GMS Composite Knitting Ind. Ltd. (New Building)

Sardaganj, Kashimpur, Gazipur-1346, Bangladesh,
(23.96859, 90.29699)

24th & 31st May & 06th September 2021

Observations

Live load at BNBC

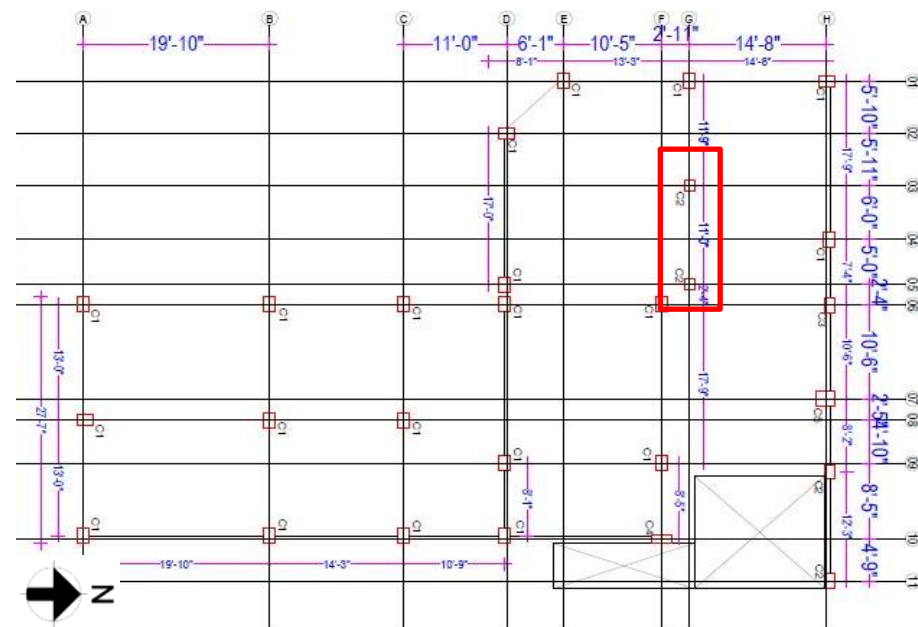
Live load at storage areas are considered as 3 KPa in prepared load plan. However, as per BNBC-Part 6 live load for light storage areas is required to be considered as 6 KPa. Building engineer is required to revise the load plan as per BNBC part-6.

As per provided structural drawing footings are in 6 feet below from the EGL

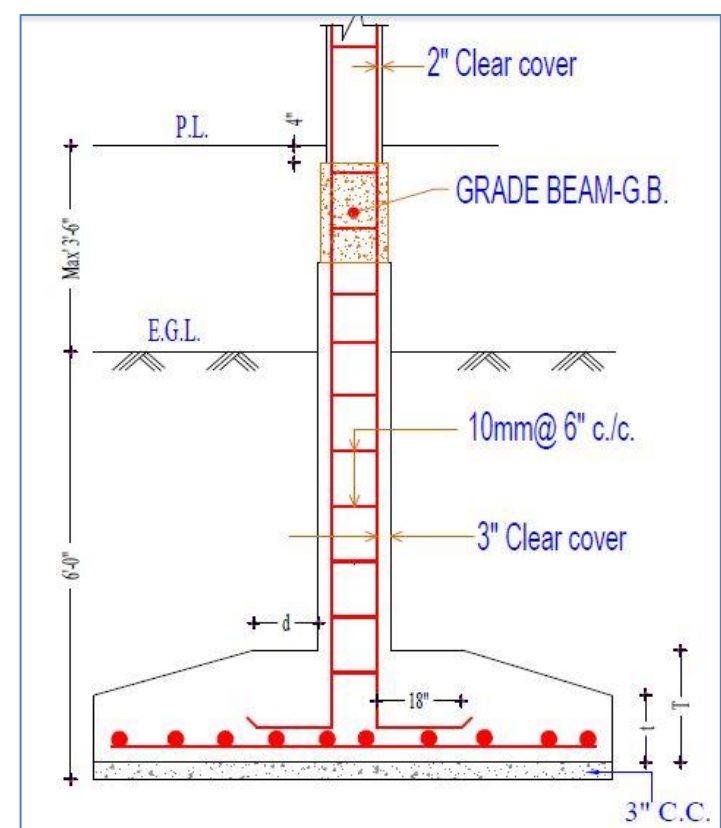
Cursory calculation indicates that internal footings of the building are stressed above design limit considering the bearing capacity from soil test report. A Detail Engineering Assessment is required carryout by Building Engineer.

3rd floor layout plan

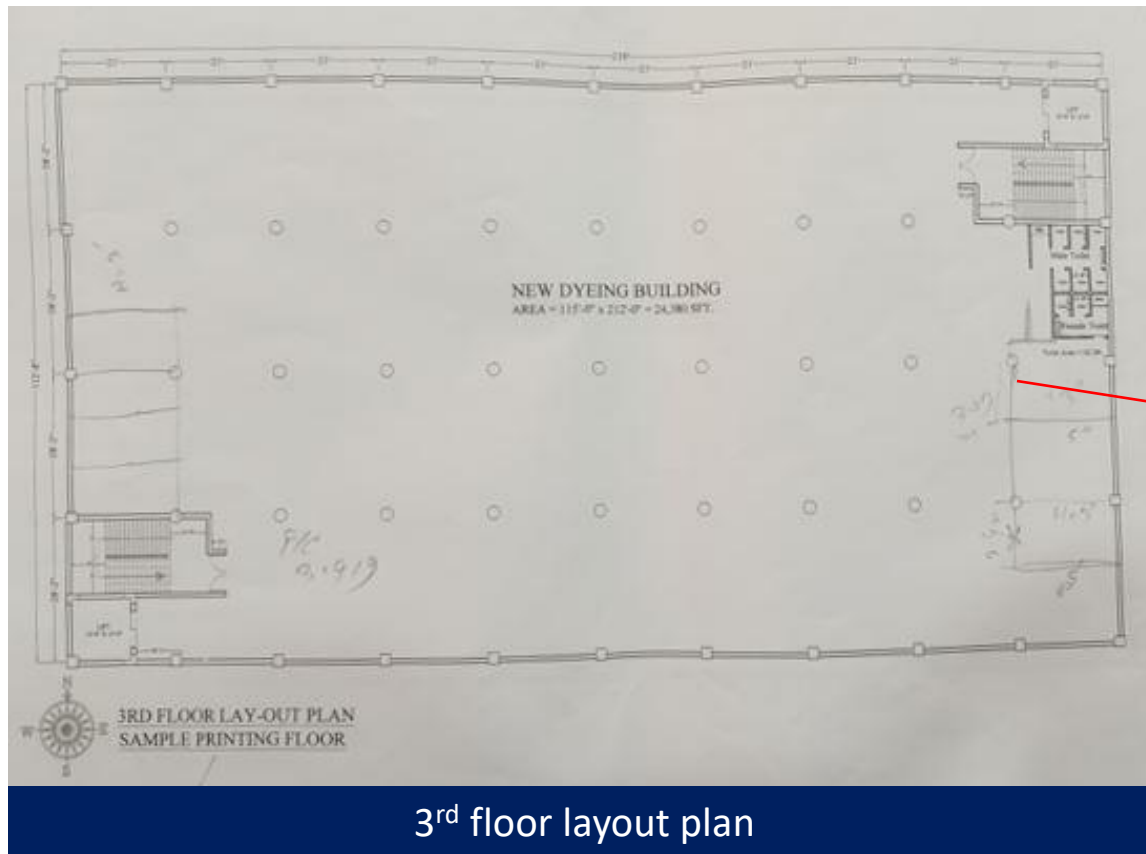
Architectural drawings are not updated as per as built condition. Toilet zone and partition walls of 3rd and 4th floor are found different with the drawings. Also, the porch of both exits are shown in the drawings.

Footing schedule without mentioning the foundation depth

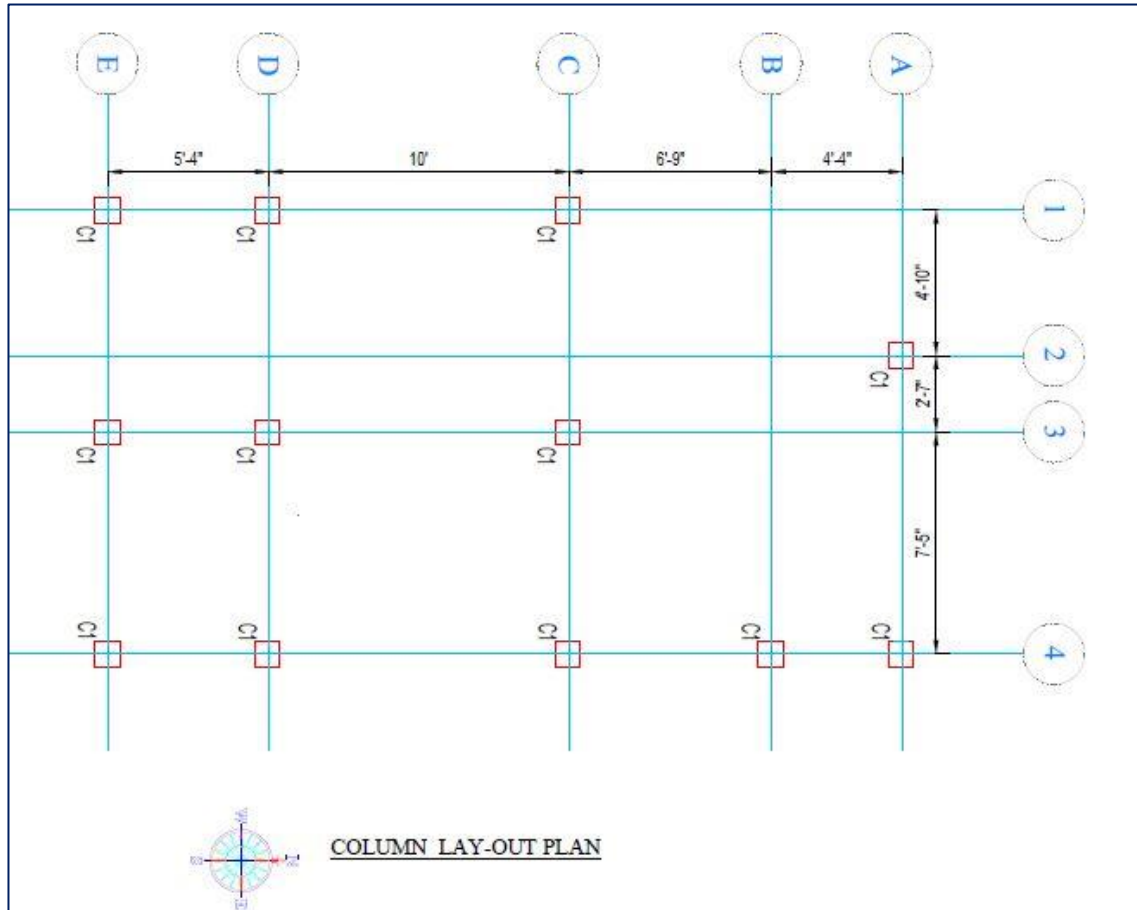
In DEA report, foundation depth has been mentioned at 4.57m but neither the foundation depth shown in footing schedule, nor any vertical section of footing has been shown in provided drawing. In addition, Bore Hole-19 shown twice in DEA report which have different soil bearing capacity. Building engineer is required to verify the foundation depth and check the adequacy of the foundation based on accurate borehole data.

Lack of lateral stability system

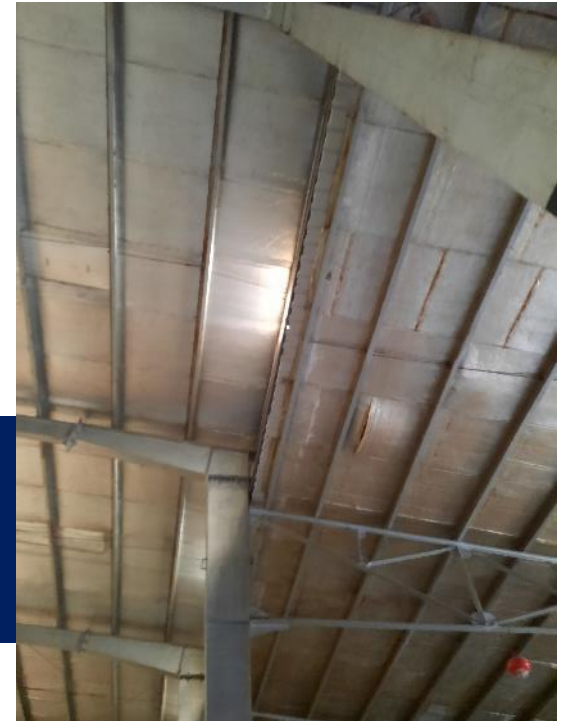
Lack of lateral stability system, inadequate structural member & poor connection details. Building engineer is required to check the lateral stability system or replace the non-engineering shed.

Loose cable bracing

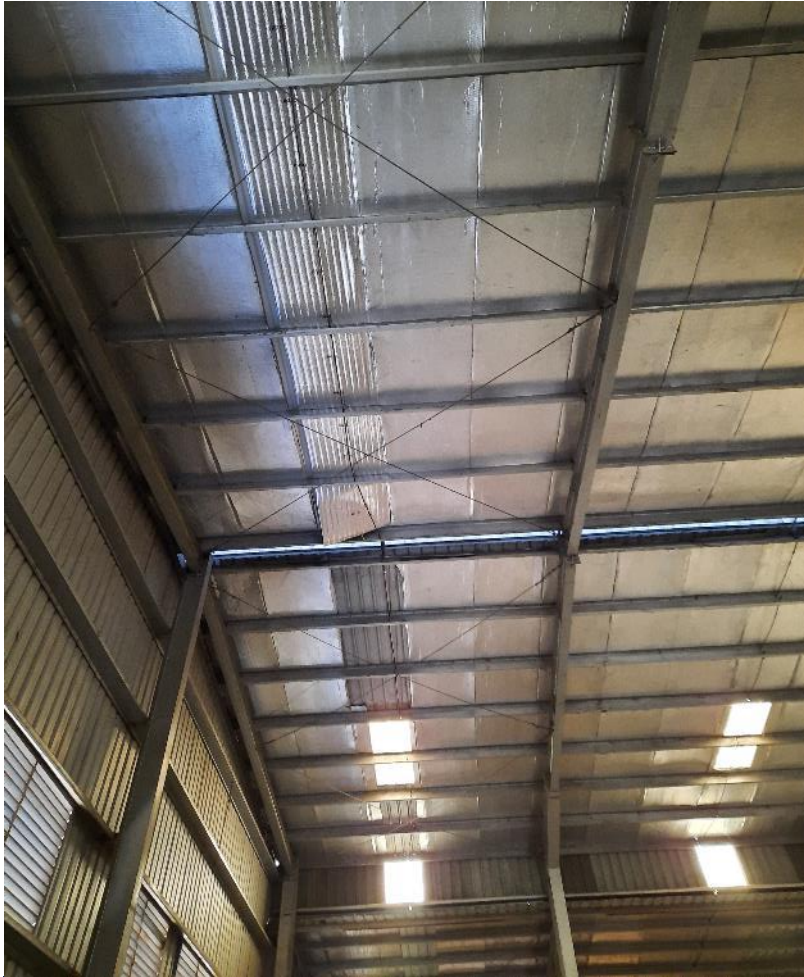
Loose cable bracing observed on roof. Building engineer is required to tighten the bracing.

Shed 8

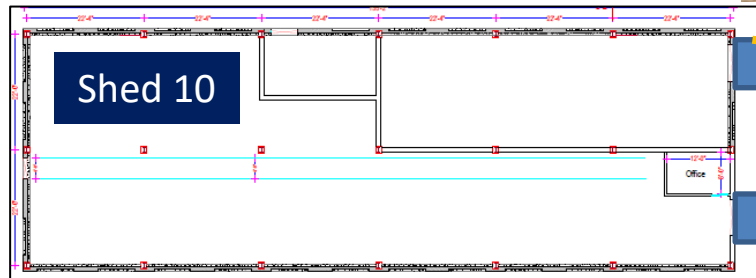
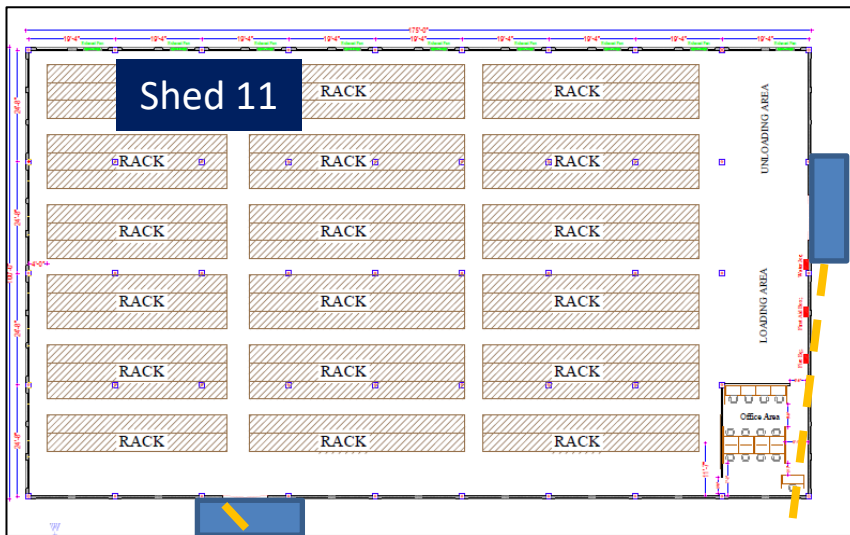
No compression strut/Load transfer media has been provided in the long direction. Building engineer is required to check the requirement of the any load transfer media in the long direction.

Wall & roof bracings are not provided. Building engineer is required to check the lateral load resisting system of the shed.

Undocumented canopy at shed 8, 10, 11 & 12.

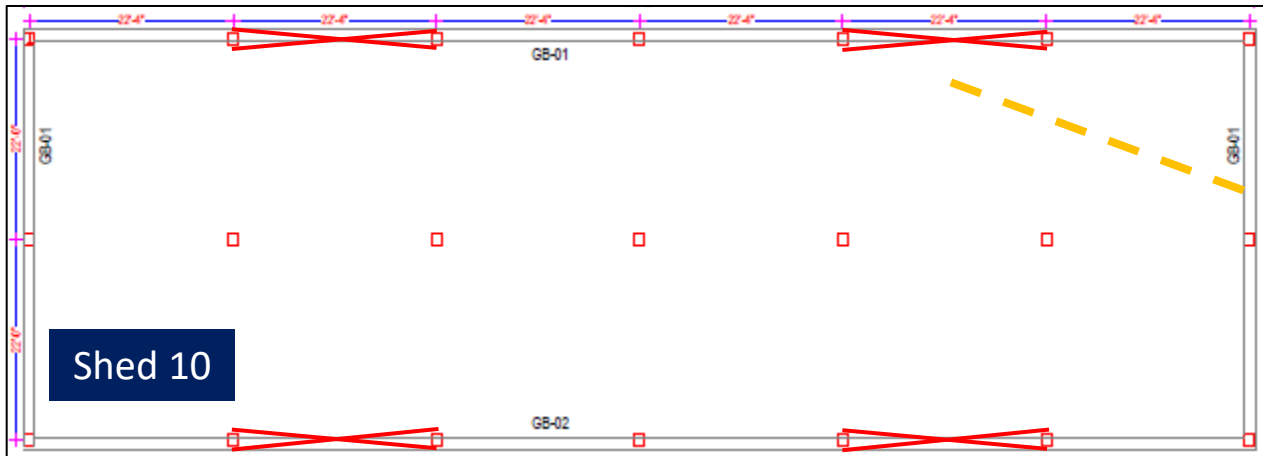
Incomplete as-built drawings and discrepancies between drawings & as-built condition.

Similarly, internal chord of Roof truss found 38x38x4 mm & other chords 50x50x5mm at shed 12(hazardous)

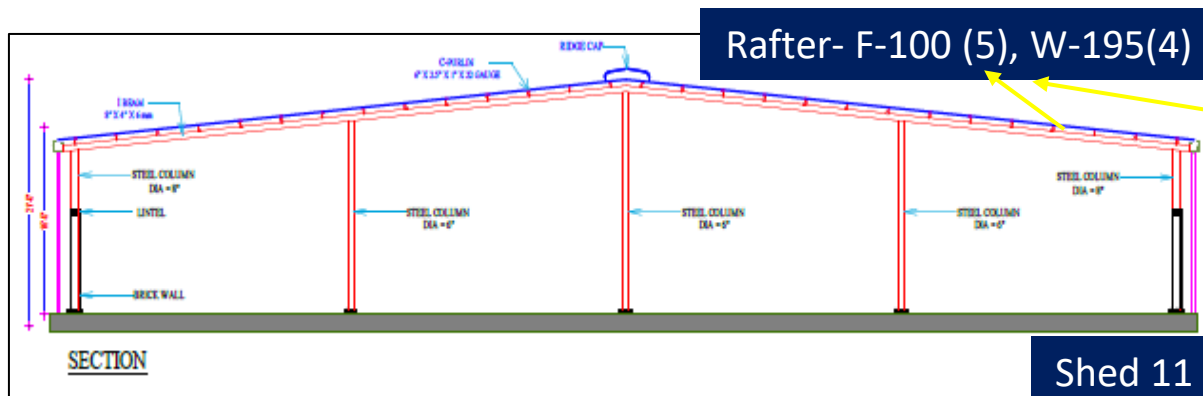
Roof truss internal chord found 38x38x4 mm instead of 50x50x6 mm at shed 9

Corrosion in steel column

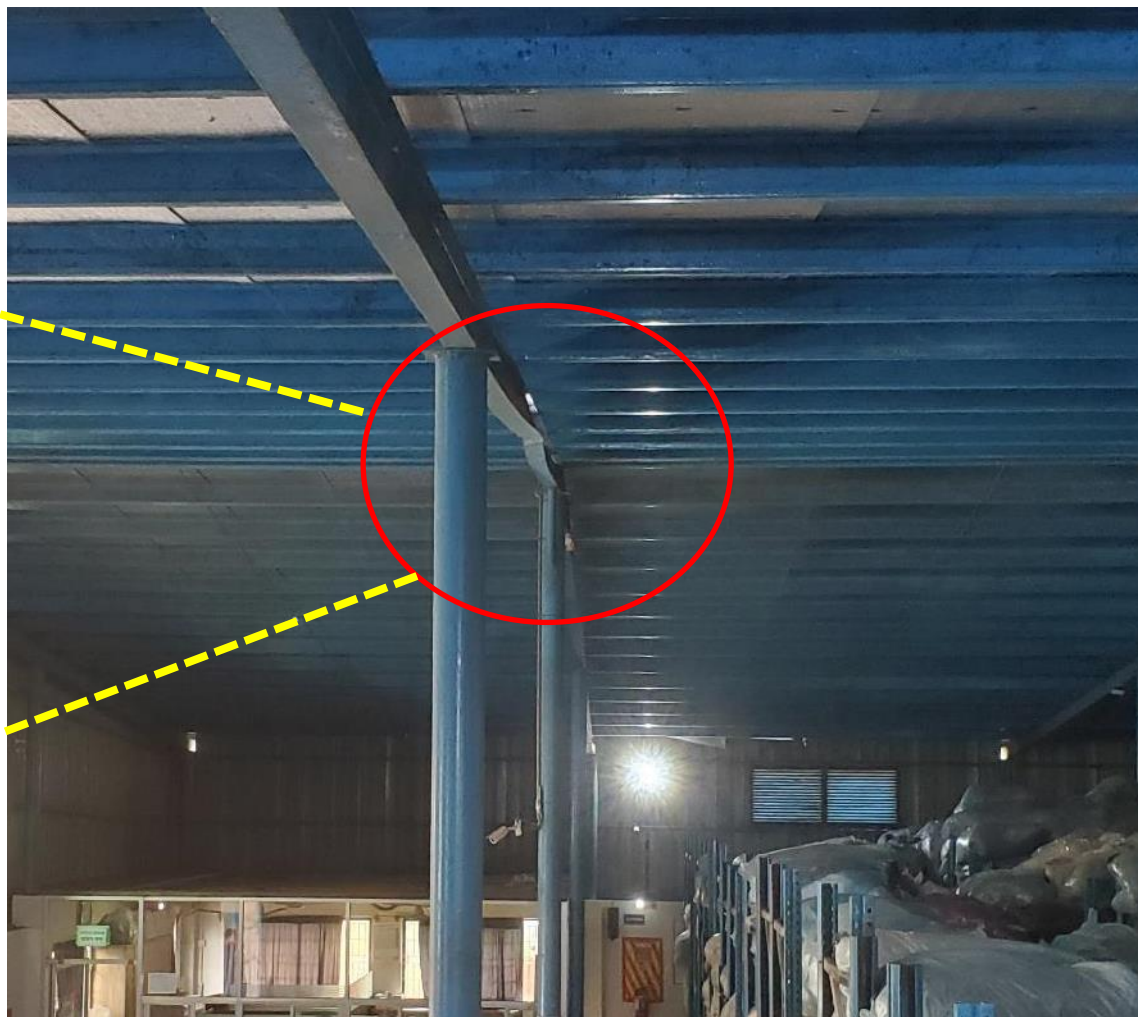
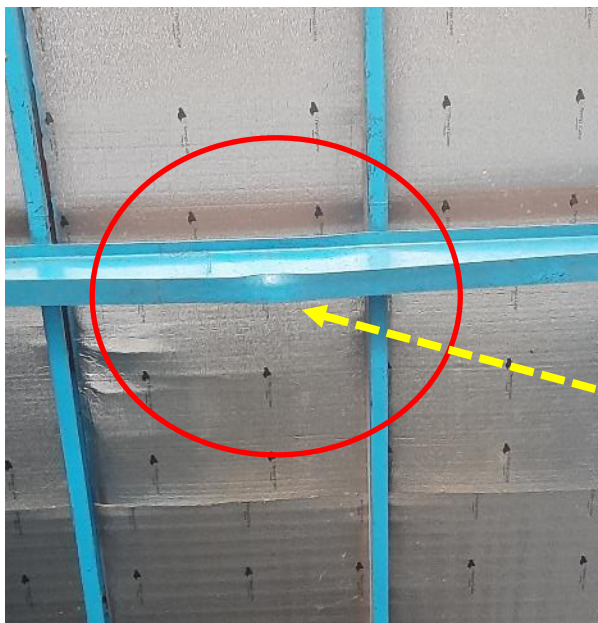
Corrosion in steel member was observed in various locations. The building engineer to investigate the reason & extent of corrosion and suggest proper remedial measure accordingly.

Shed 13

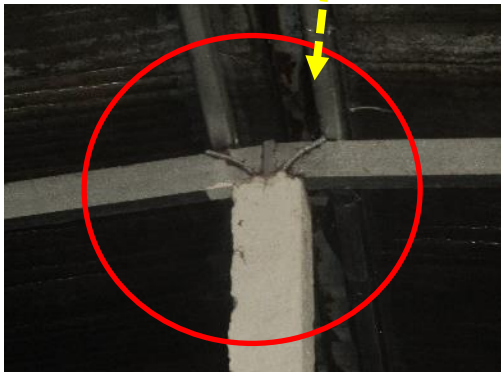
Apparently inadequate steel members,
Poor connection details and no clear/defined load path observed.
Seemingly non-engineered shed.
Building engineer is required to check
the stability of the shed or replace by an
engineered structure.
